**Bulletin | Danfoss Turbocor Compressors**

# **Customer Notification**

**B-CN-264-EN REV A**

SUBJECT: Plunger Update

Figure 1 - Plunger Assembly Seal Location

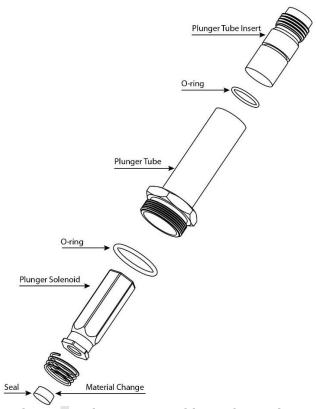
The purpose of this bulletin is to inform our customers that we have changed the material of the seal located in our plungers. This will impact new compressors as well as our spare part kits. Refer to Figure 1 below for the location of the seal.

We have changed this seal so it can be more tolerant to refrigerant contamination by oil. Even though this seal has been changed, we still ask that our customers ensure that the system is oil-free prior to compressor operation.
